***Vastern Road
Development
Energy Strategy
Review***

Final report

**Reading Borough
Council**

Reading Borough Council (RBC) has commissioned Element Energy to provide a critical review of Hodkinson’s proposed energy strategy for the Vastern Road redevelopment by Berkeley Homes. The intention of the review is to ensure the energy strategy meets council energy and carbon policy.

Figure 2 Illustration for proposed heat supply strategy per dwelling

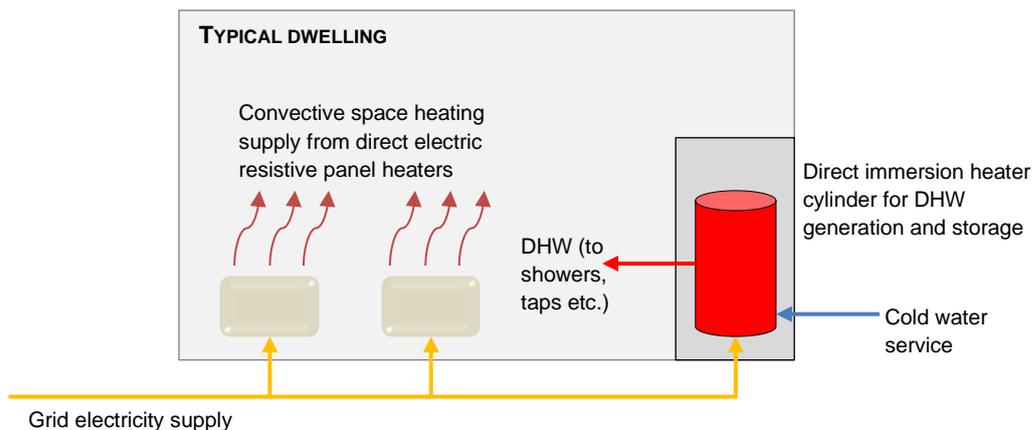
The residential space heating supply strategy has been flagged as a concern by RBC due to use of direct electric panel heaters in dwellings. Whilst the panel units take advantage of low-carbon grid electricity supply, they are also inefficient relative to alternative heat supply methods and thus potentially increase space heating costs for dwelling occupants. A simple illustration of the proposed heat supply strategy per typical residential dwelling on the development is provided in Figure 2.

It is recommended that Hodkinson provide a comparative analysis between a centralised heat pump supply system and direct electric heating for the Vastern Road development. The detail to be included must consider the following elements:

Figure 3 Screen grabs from the Environment Agency’s “GSHP Screening Tool”, showing Reading town centre is favourable for open-loop systems²

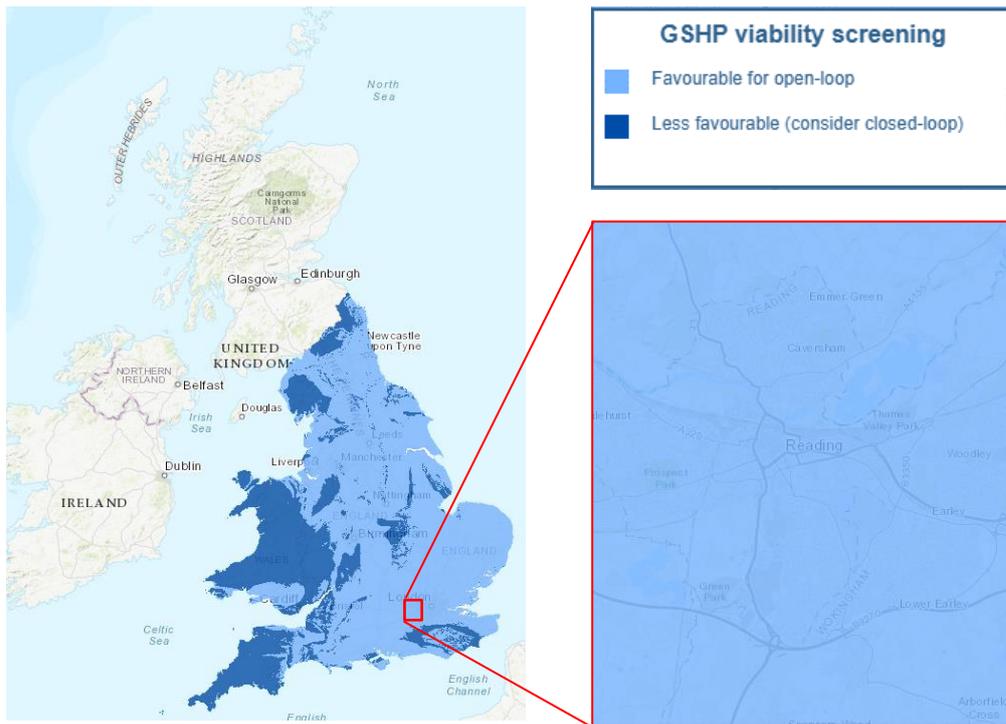
Open-loop GSHP systems require at least two boreholes for abstraction and reinjection of groundwater from aquifers for generating heat. Reading is shown by the Environment Agency’s “GSHP Screening Tool” as being favourable for open-loop systems (Figure 3). Open-loop GSHP should remain as an option to be investigated in more detail by Hodkinson; this will likely require a hydrogeological survey to test feasibility and permits from the Environment Agency. A relatively inexpensive preliminary assessment is available from the British Geological Survey that can determine potential for open-loop GSHP: https://shop.bgs.ac.uk/Shop/Product/GRC_C108. **It is recommended that Hodkinson assess the potential for open-loop GSHP using this resource.**
